ST. TAMMANY PARISH

Addendum No.: 1

Bid#: 24-43-2

Project Name: Brewster Road Sewer Consolidation

SHEET NO.
10PP-09

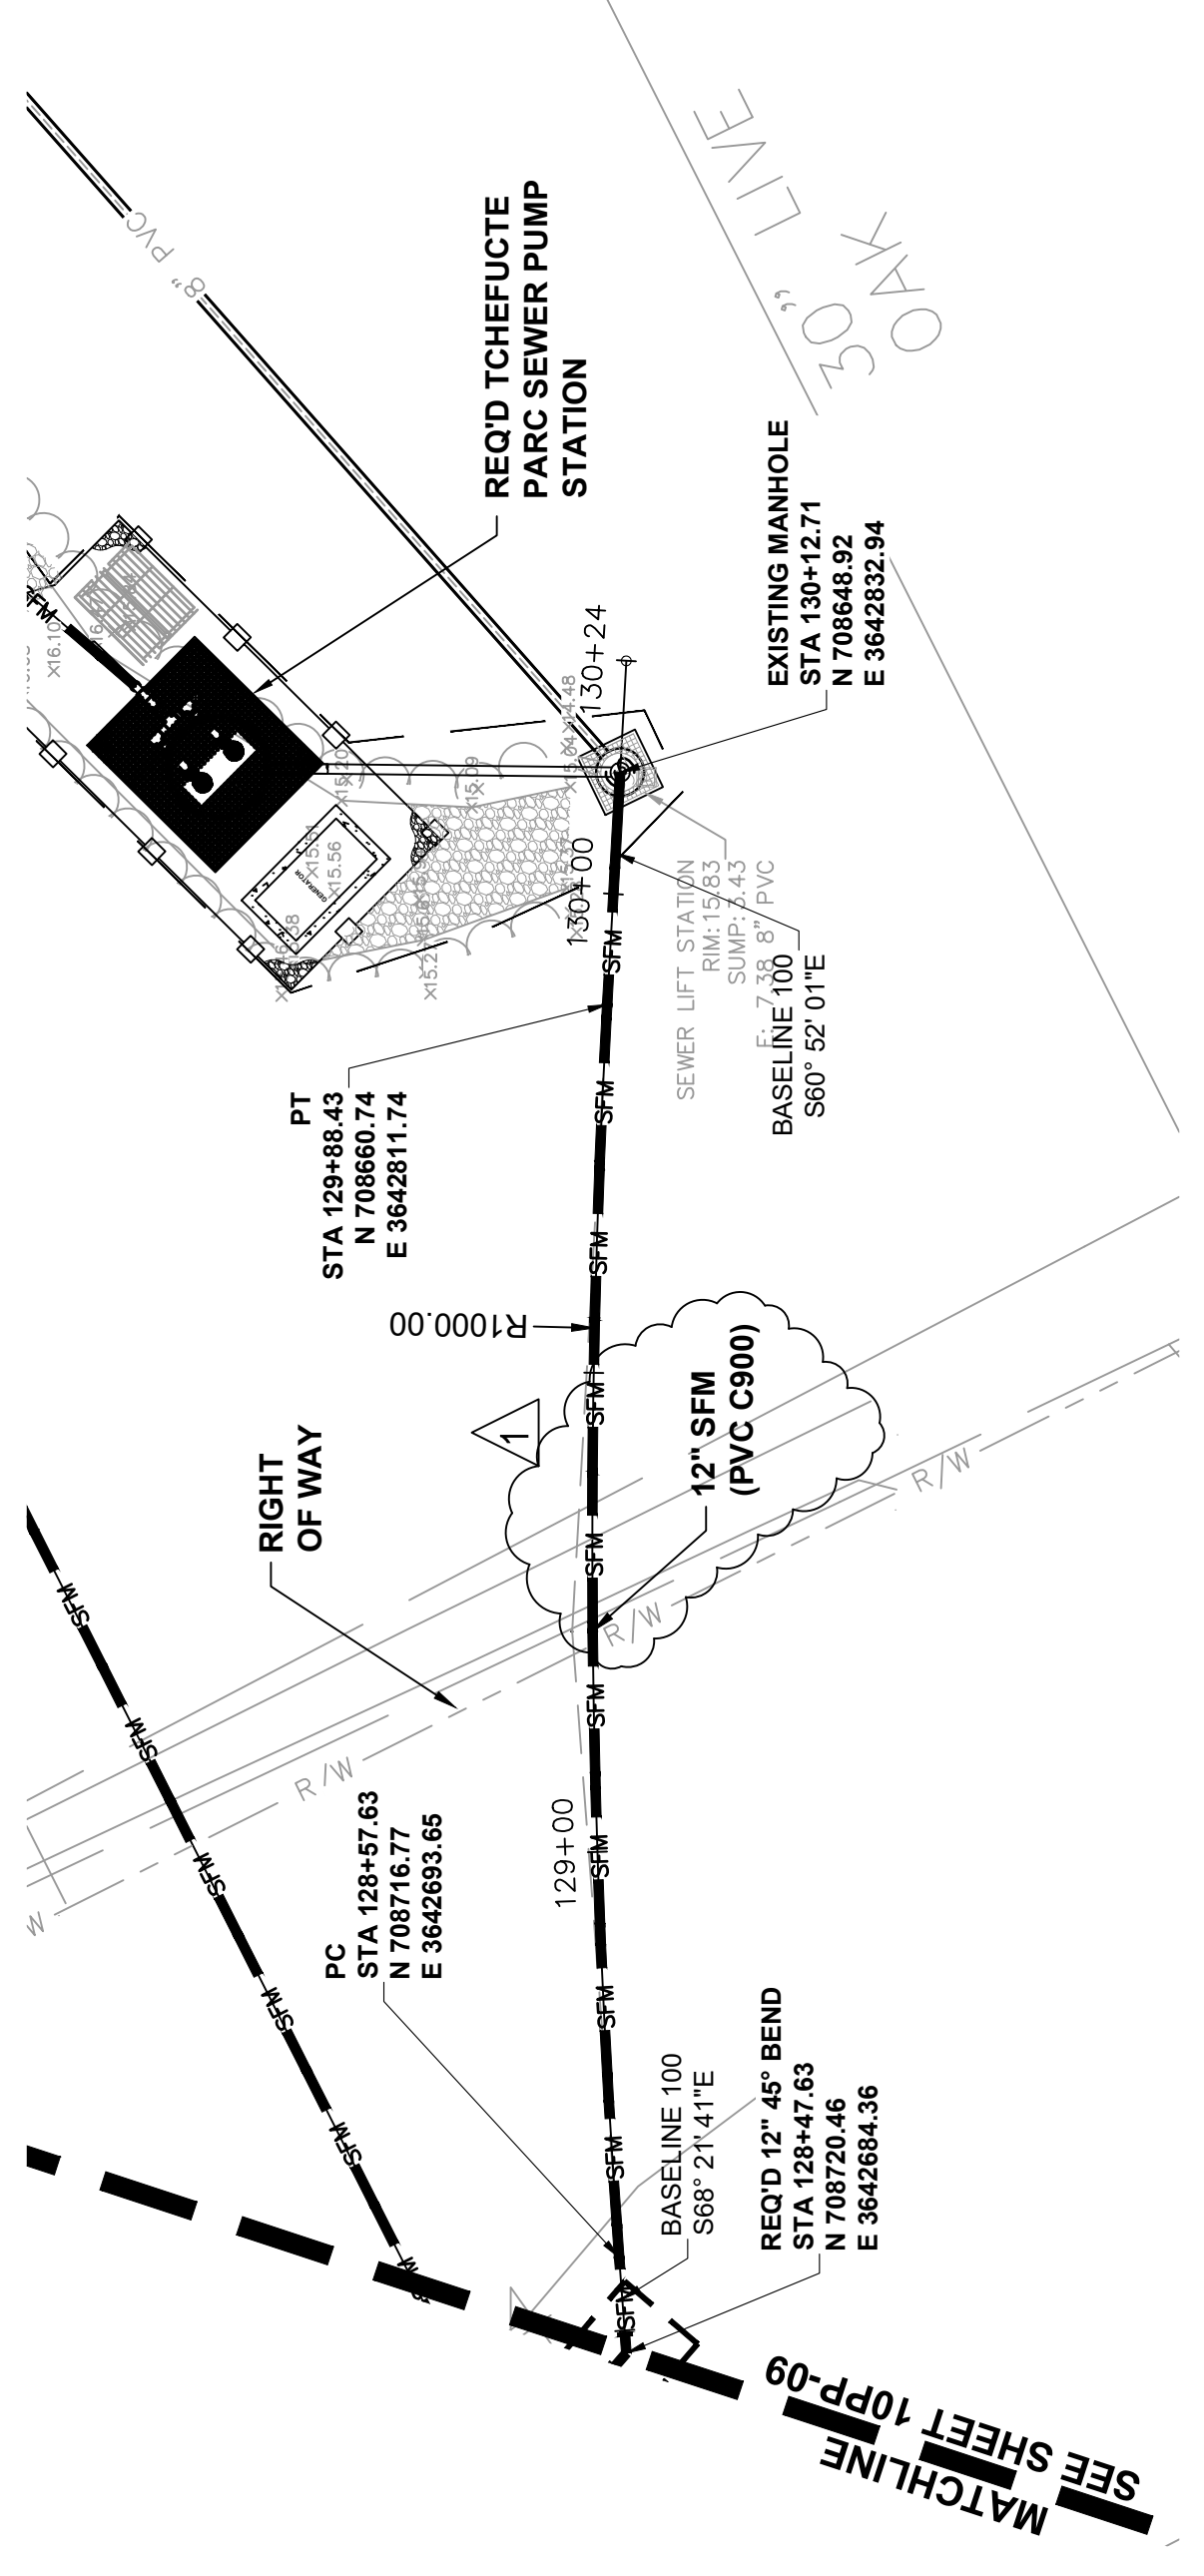
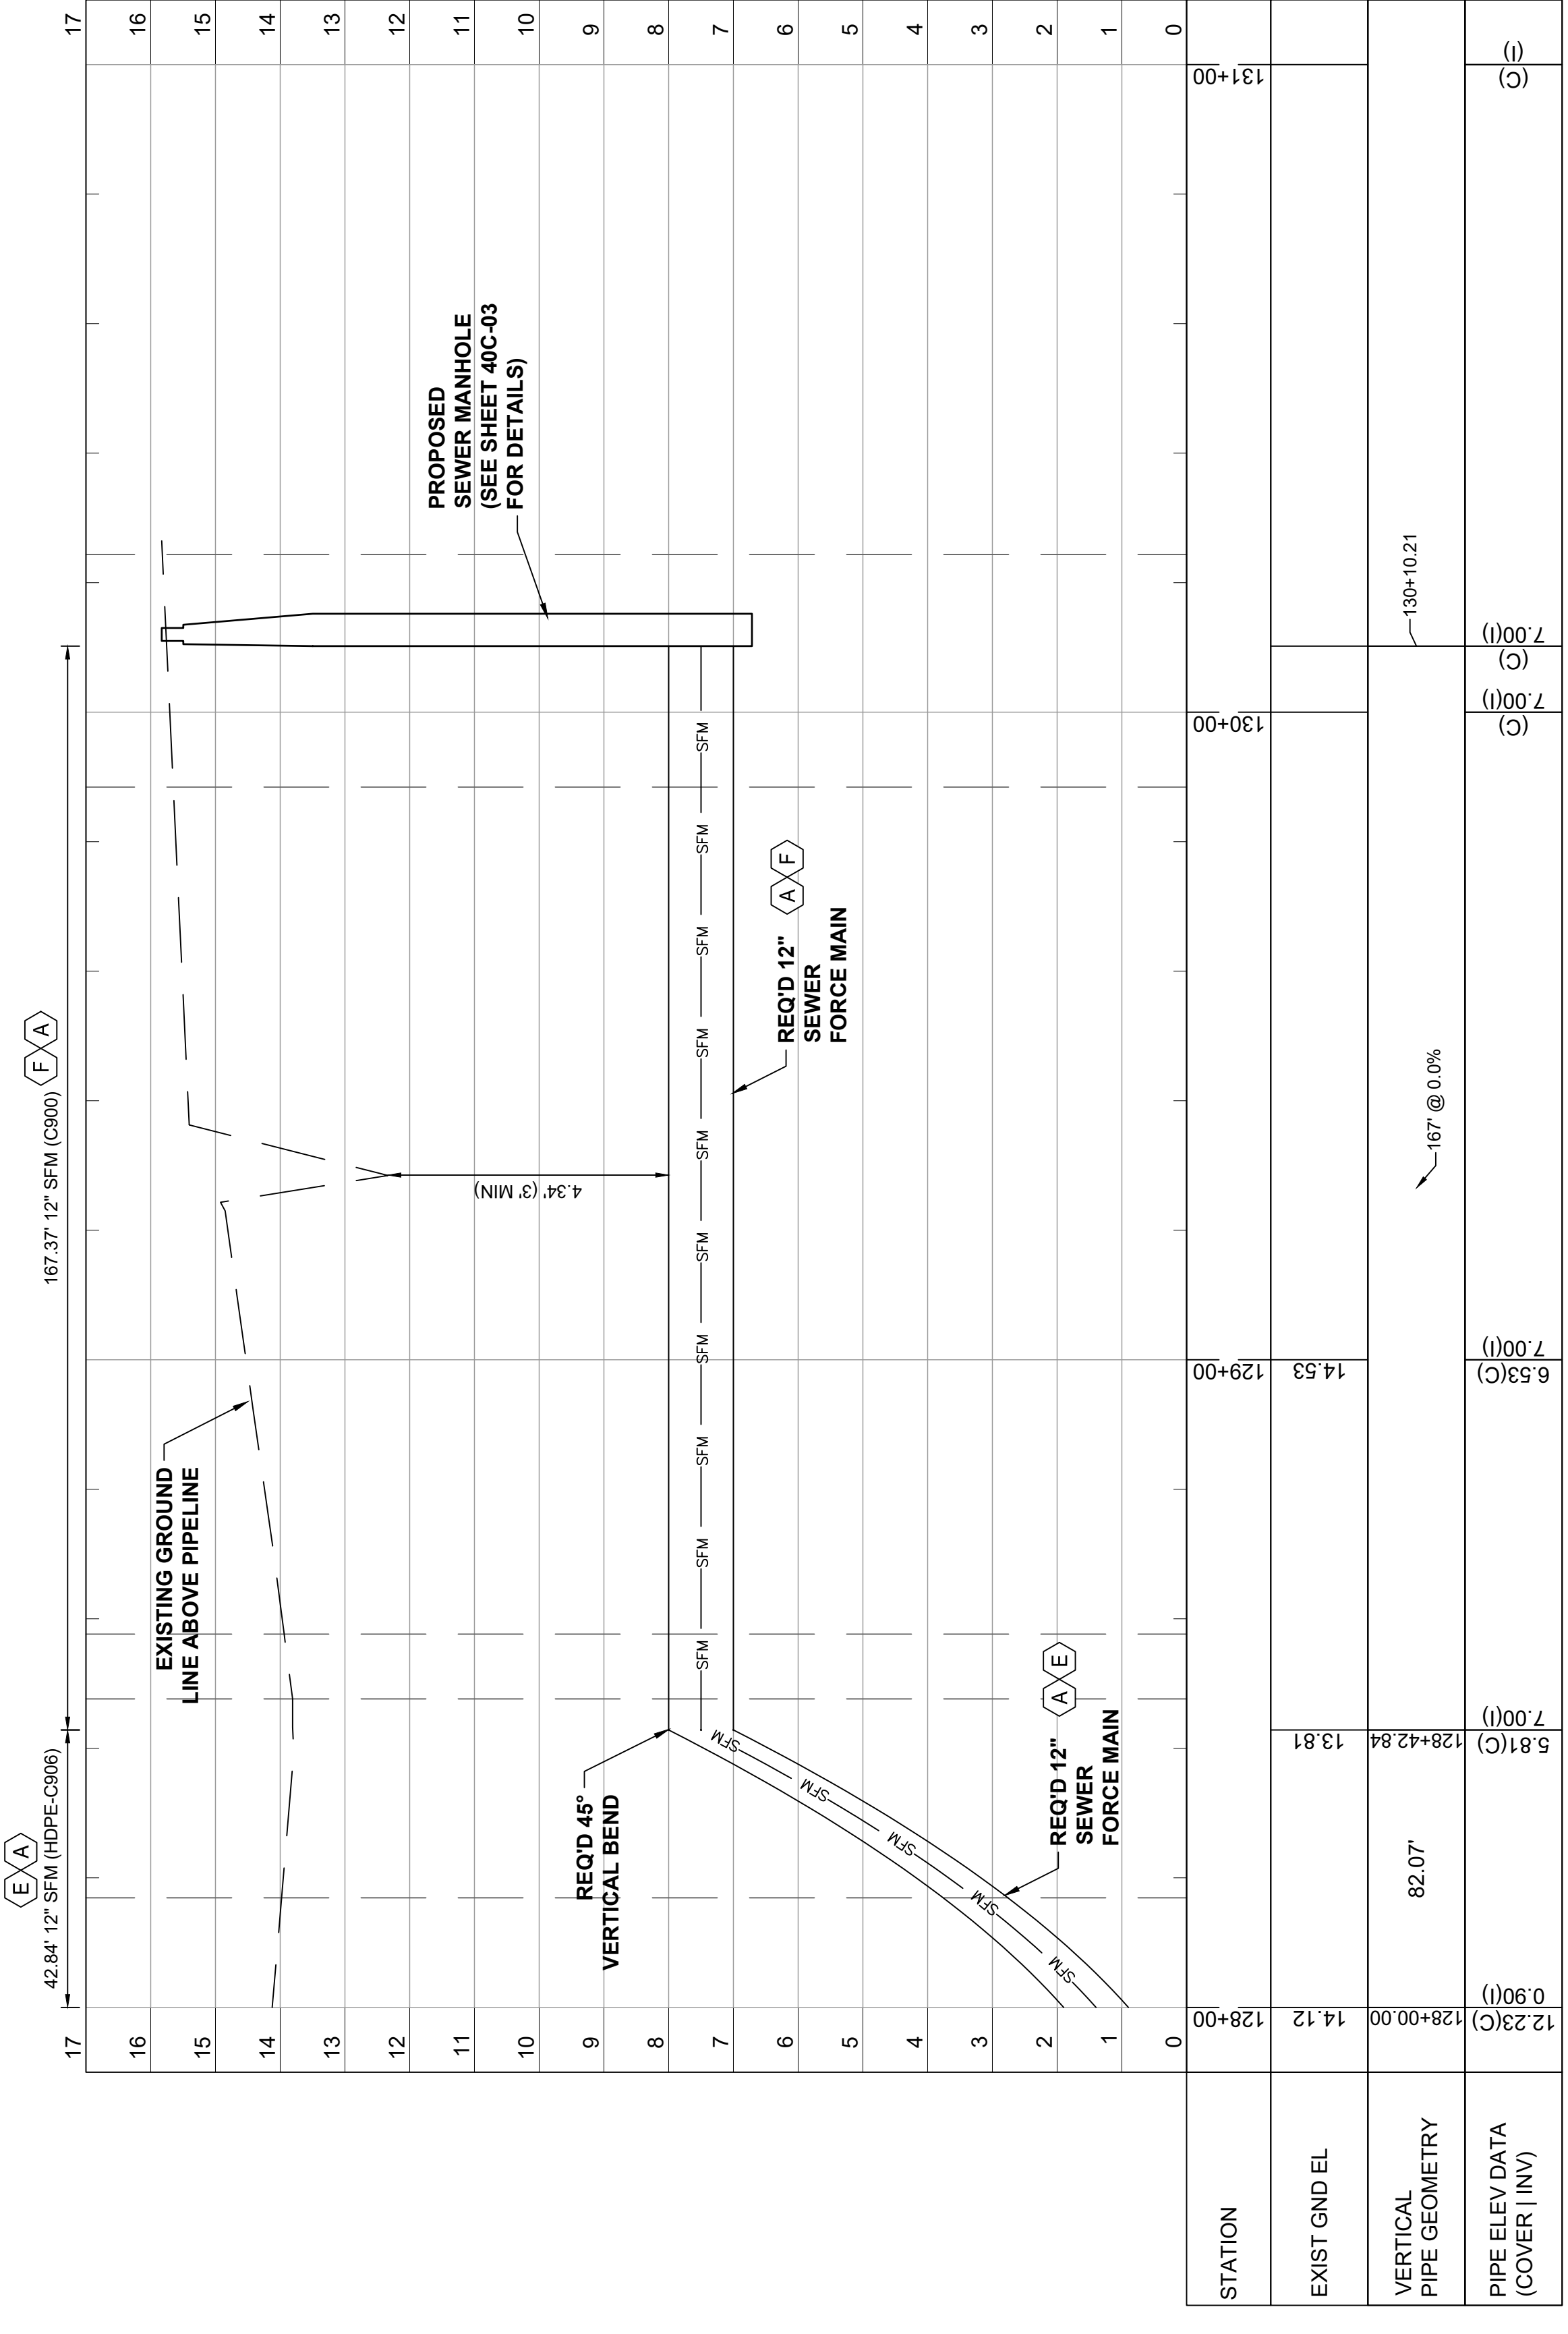
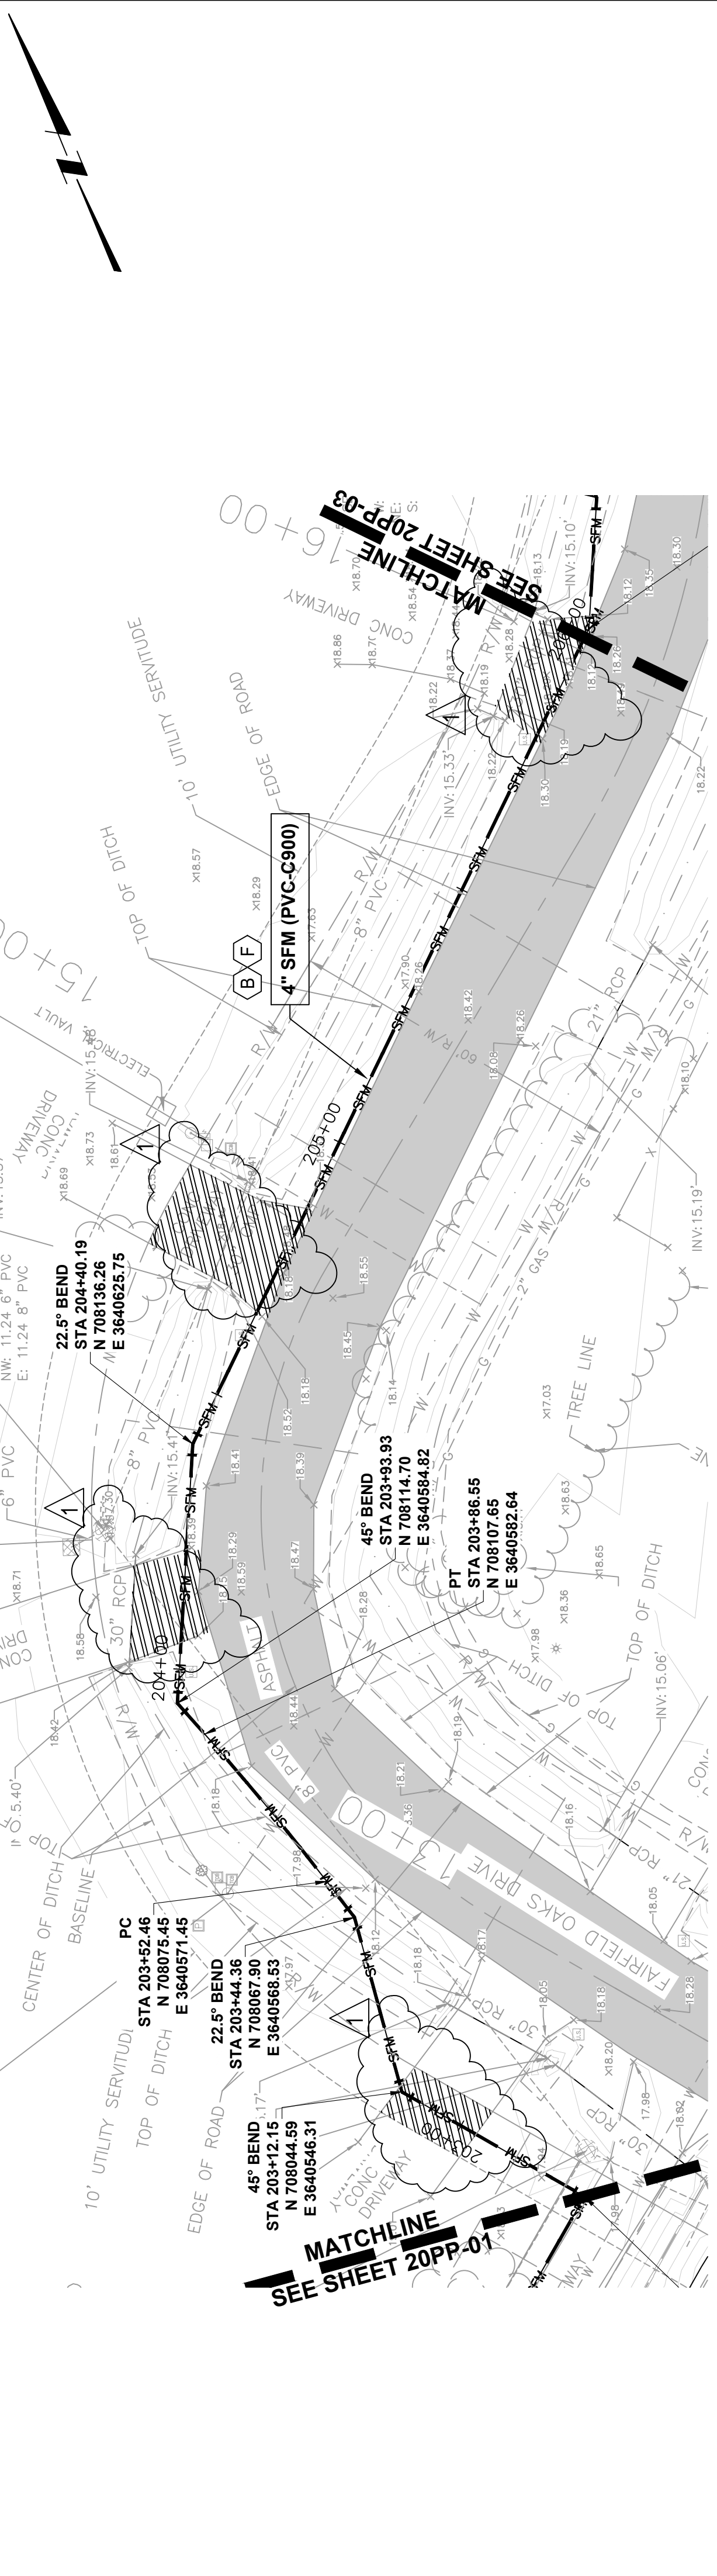
- c. DELETE Drawing 10PP-07 and REPLACE with the attached REVISED Drawing 10PP-07.
 - d. DELETE Drawing 10PP-09 and REPLACE with the attached REVISED Drawing 10PP-09.
